LIBERTY PARK

RE: SUB 2002-41 -- Final Plat of Liberty Park Addition

STAFF REPORT

CASE NUMBER: SUB 2002-41 -- LIBERTY PARK ADDITION

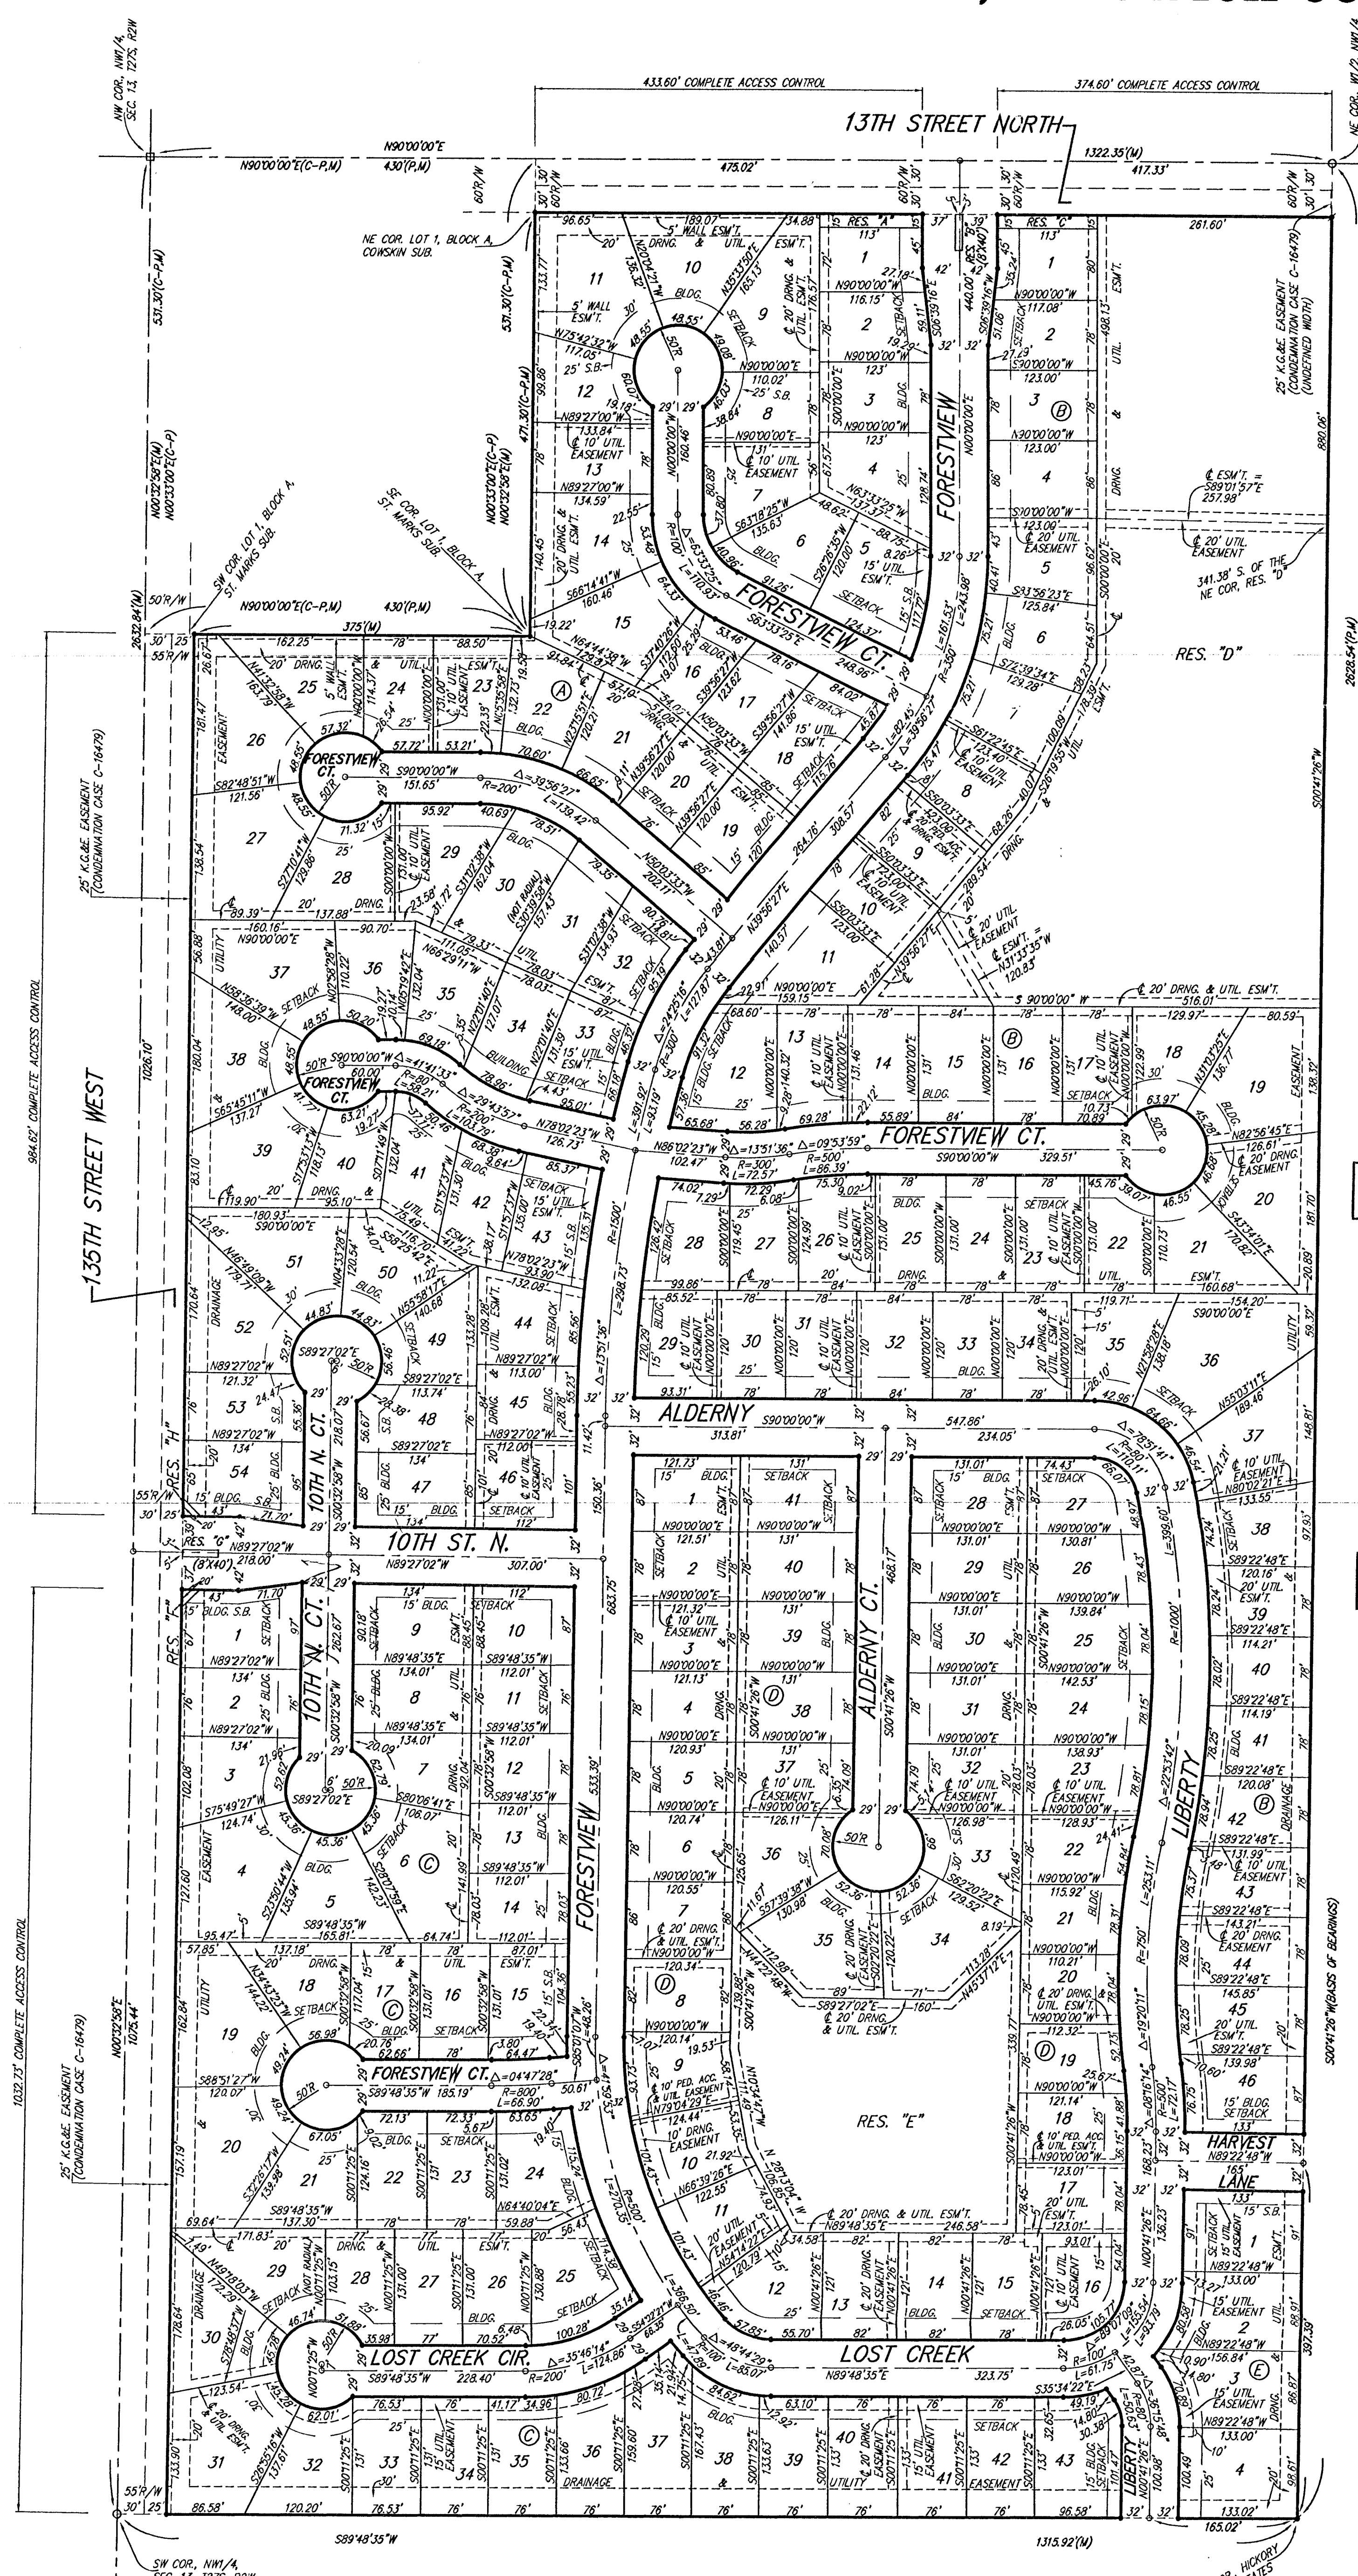
At the regular meeting of the Subdivision Committee of the Metropolitan Area Planning Commission on Thursday, July 18, 2002, the above captioned plat was considered. The action of the Committee was to approve the one-step final plat, subject to the following:

- B. The applicant shall guarantee the extension of sanitary sewer and City water to serve the lots being platted.
- C. If improvements are guaranteed by petition, a notarized certificate listing the petitions shall be submitted to the Planning Department for recording.

- D. City/County Engineering needs to comment on the status of the applicant's drainage plan. City Engineering has approved the drainage plan. A guarantee is required.

- E. The applicant shall guarantee paving of 13th Street North from Hickory Creek to Forestview including a left turn bay at Forestview. The applicant shall also guarantee construction of a left turn bay on 135th Street at Alderny Ct.

- F. A street stub should be shown to the south for increased mobility when development occurs in this location.

- G. The Applicant shall guarantee the paving of the proposed streets. The guarantee shall also provide for sidewalks on at least one side of all through, non cul-de-sac streets.
- H. It is recommended that Reserves D and E be extended to the streets by access easements or by extensions of the Reserves between the lots to increase their accessibility and usefulness for all homeowners in the Addition

- I. Provisions shall be made for ownership and maintenance of the proposed reserves. The applicant shall either form a lot owners' association prior to recording the plat or shall submit a covenant stating when the association will be formed, when the reserves will be deeded to the association and who is to own and maintain the reserves prior to the association taking over those responsibilities. This covenant shall also provide for the Homeowners' Association to maintain the "parking strip" located between this site's north property line and driving surface for 13th St. North.

- L. The wall easement shall be referenced in the plat's text.
- M. The City Fire Department/GIS needs to comment on the plat's street names. 10th N. Ct. should be revised to 10th Ct. N.

- N. For any lots with existing tree rows that may be impacted by the installation of utilities, it is recommended that 30-ft utility easements be platted in order to allow for the installation of the utilities without damage to such tree rows. The applicant has agreed to plat an appropriate easement to avoid damage to the tree row.

- O. The plat's text shall include language that a drainage plan has been developed for the plat and that all drainage easements, rights-of-way, or reserves shall remain at established grades or as modified with the approval of the applicable City or County Engineer, and unobstructed to allow for the conveyance of stormwater.

- W. The representatives from the utility companies should be prepared to comment on the need for any additional utility easements to be platted on this property. Westar Energy has requested additional easements.

The applicant has extended Liberty to the south line of the plat as requested.

Pedestrian easements have been platted as requested.
